November 17, 2015

Re: Environmental Assessment
Frey Farm Landfill Vertical Expansion
Permit No. 101389
Manor Township, Lancaster County

The Department of Environmental Protection (DEP) has completed its initial environmental assessment review of your application and has the following comments:

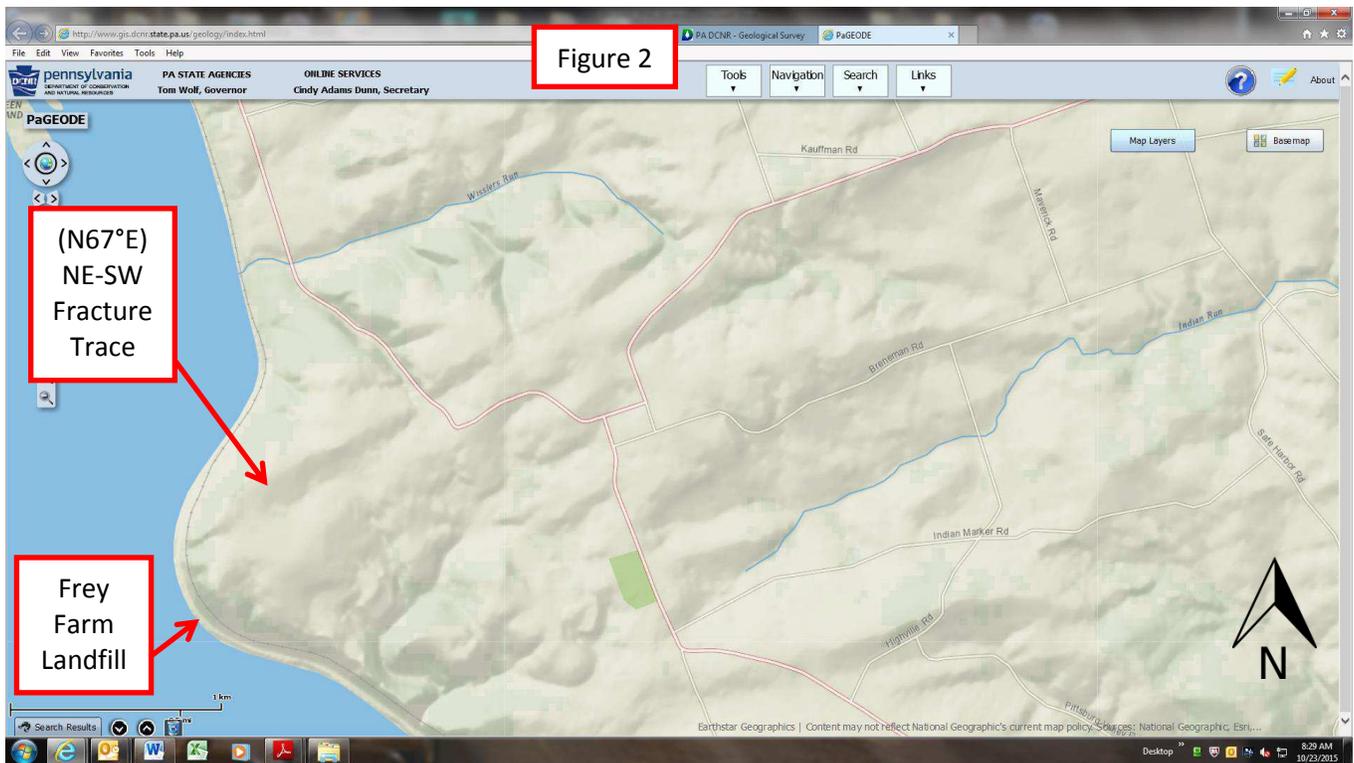
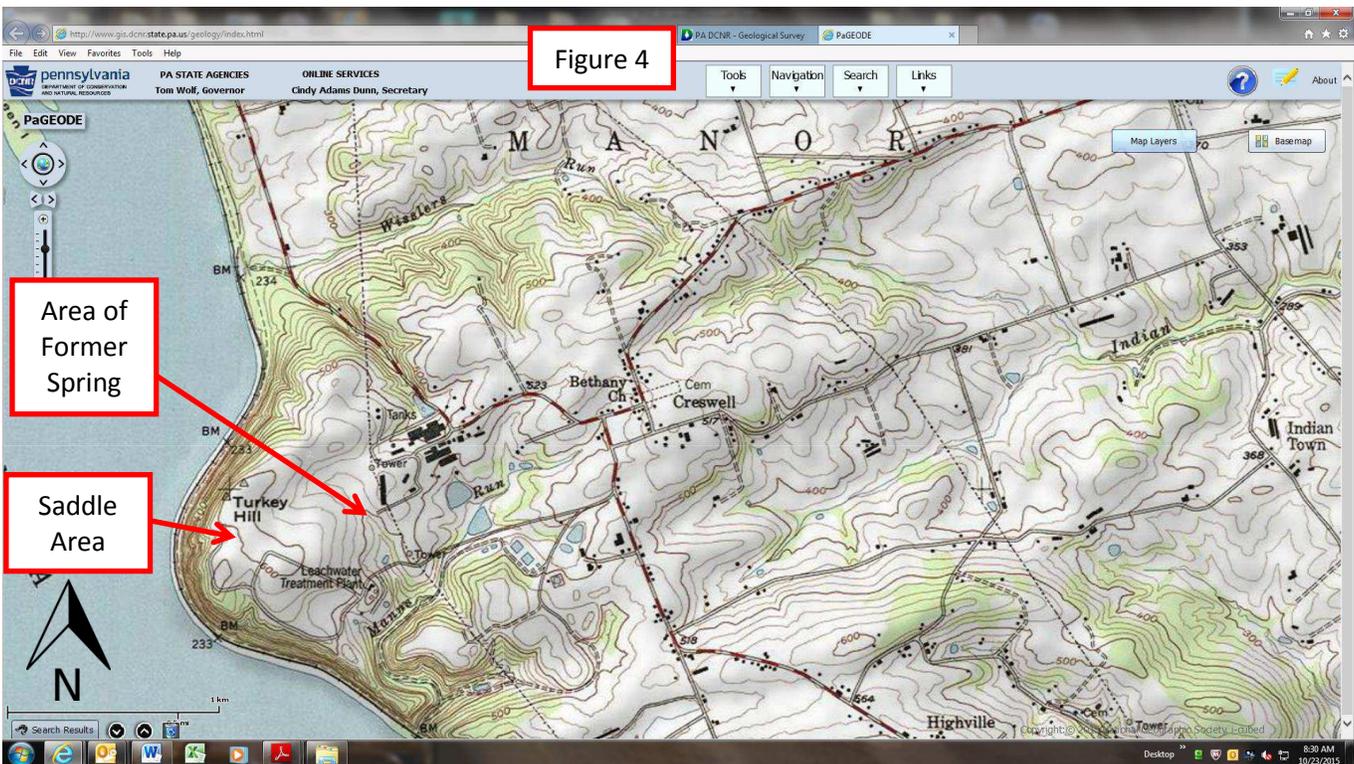
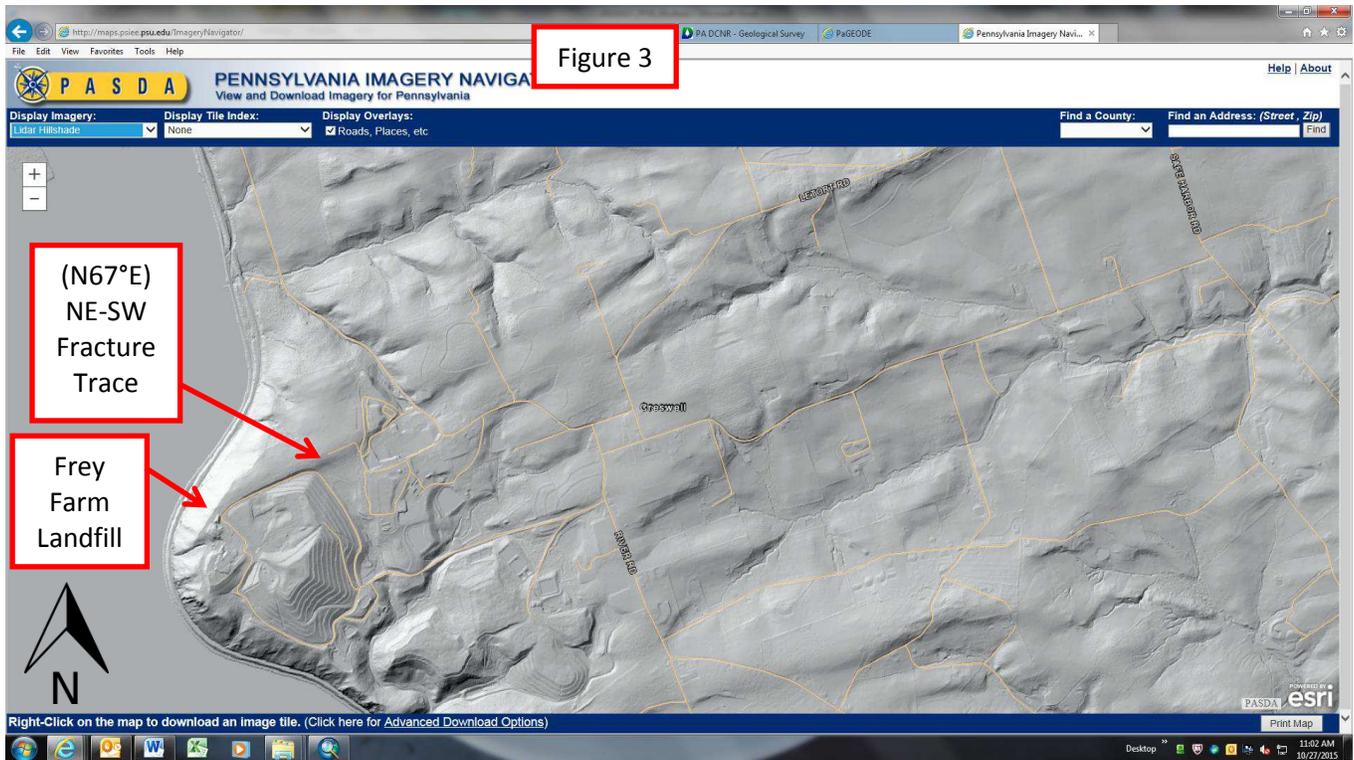
- 3) The DCNR website at <http://www.gis.dcnr.state.pa.us/geology/index.html> and Penn State website at <http://maps.psiee.psu.edu/ImageryNavigator/> provide access to aerials in addition to National Geographic, topographic, light and radar (Lidar), and/or geologic maps of this area. As noted on the attached aerials and maps (i.e. Figure 1, Figure 2, and Figure 3), a fracture or possible fault trends NE-SW in the vicinity of the north side of the existing landfill footprint and is believed to correlate with the N67°E fracture trace documented on the *Phase I, Sheet 8 - Geologic Map* and is located beneath the northern side of the existing disposal area and in close proximity of the north and northwest sides of the proposed FFVE Mechanically Stabilized Earth (MSE) berm. As documented on the attached topographic map (Figure 4), this fracture/fault bisects a topographic high creating a saddle area (i.e. a low point between two areas of higher ground) on the west side of the landfill.

Figure 6

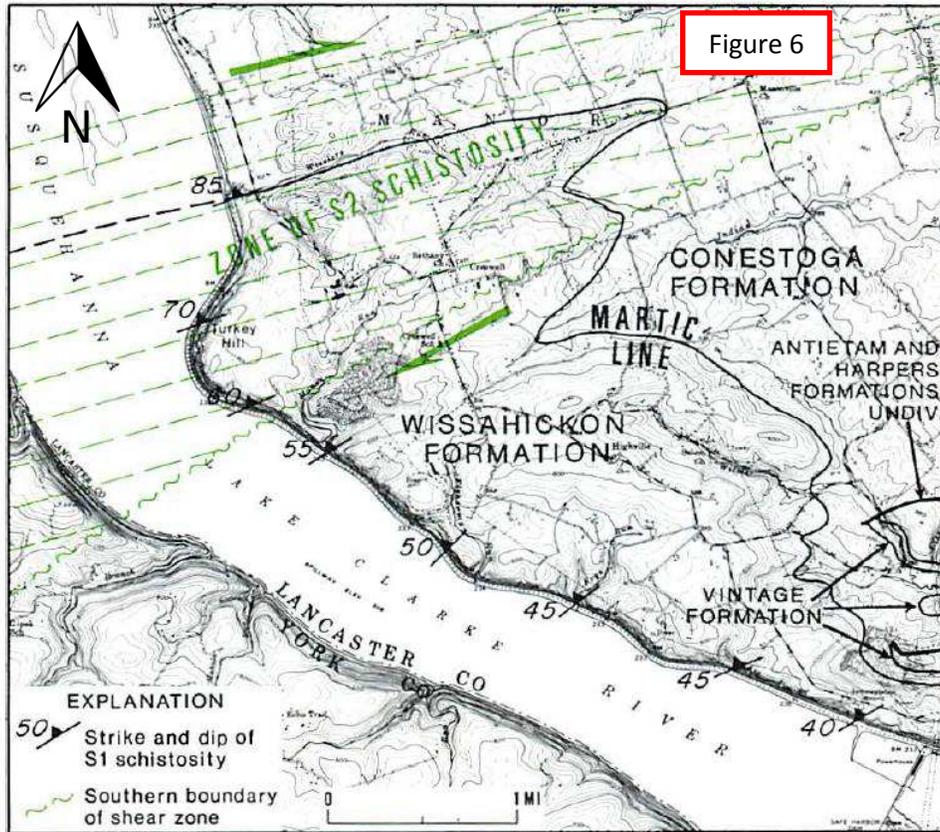
- c) The underlying geology is complexly deformed in the vicinity of Turkey Hill and the proposed FFVE. The attached Figure 6, taken from Pennsylvania Geology (April 1990) publication, illustrates the highly deformed Zone of S2 Schistosity in the vicinity of Turkey Hill, which is more highly deformed than the S1 Schistosity Zone located to the south in-between Turkey Hill and Safe Harbor. The Pennsylvania Geology publication documents that:

“The Wissahickon schists and phyllites bear interesting schistosity relationships in the area between Safe Harbor and Turkey Hill. At Safe Harbor, schistosity in Wissahickon schist is defined by parallel alignment of coarse chlorite, muscovite, biotite, and planar aggregates of

plagioclase feldspar and quartz (S1). This S1 schistosity strikes 245° to 260° and dips moderately 40° to 50°NW. North of Safe Harbor, the S1 schistosity gradually steepens. As Turkey Hill is approached from the south, the schistosity (S1) progressively shows signs of weak to intense upright crenulation (small-scale folding having wavelengths up to a few millimeters). At Turkey Hill, crenulation of the S1 schistosity was so intense that a new subvertical schistosity (S2) striking 070° developed and practically obliterated the S1 schistosity. This new (S2) schistosity is now defined by parallel alignment of very fine (submillimeter) muscovite and chlorite crystals and recrystallized planar quartz aggregates. Diamond-shaped profiles of intersection lineations (S2 x S1) clearly show the relative timing between the two schistositities."

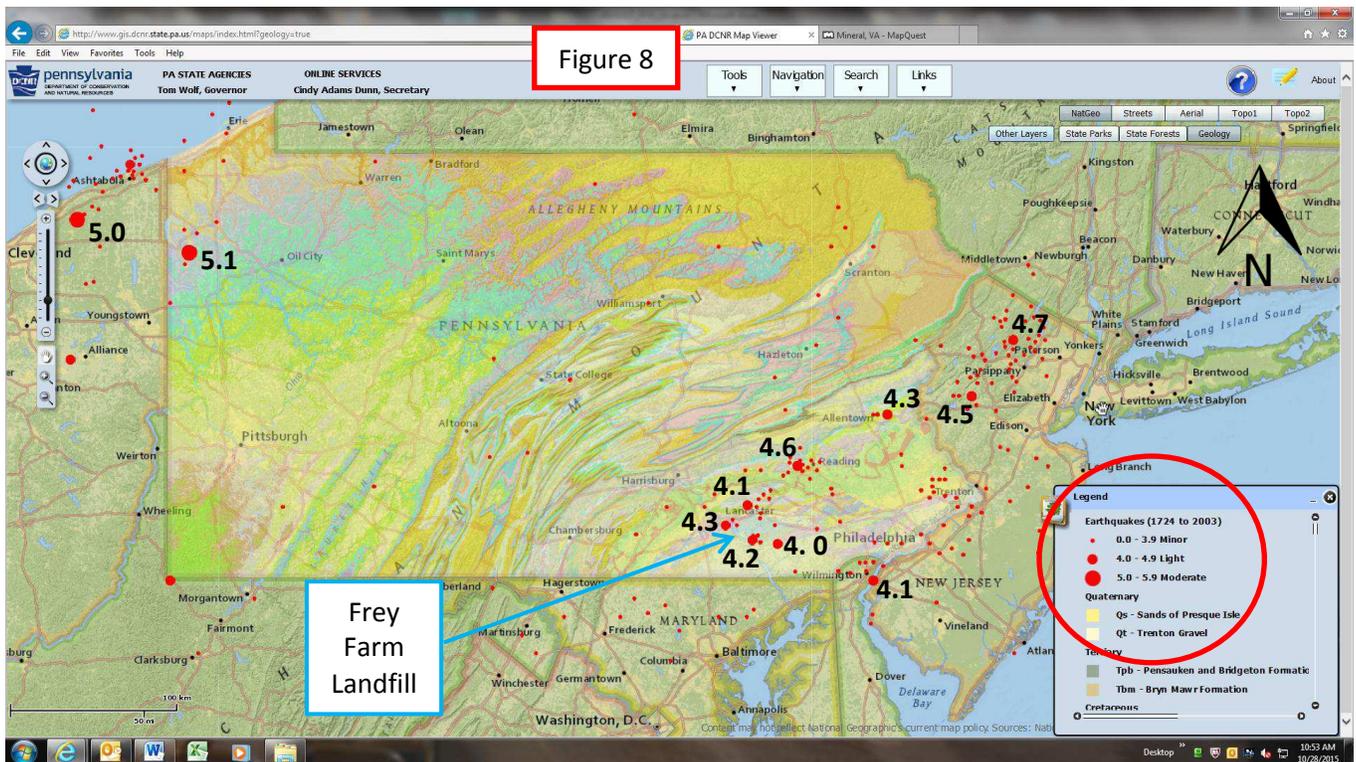
Seismic activity has been documented higher than normal for this area of Pennsylvania due to the nearby Martic Line. As noted on Figure 7, two locations in close proximity of the Frey Farm Landfill documented earthquake activities in 1984 and 1989, at 4.2 and 4.3 magnitudes, respectively. These two points are located just outside the 5-mile radius of the Frey Farm Landfill as noted on Figure 7. The attached Figure 8 illustrates Pennsylvania statewide seismic activity. Both of these maps were created using earthquake data (i.e. circa 1724 to 2003) downloaded from the DCNR website.
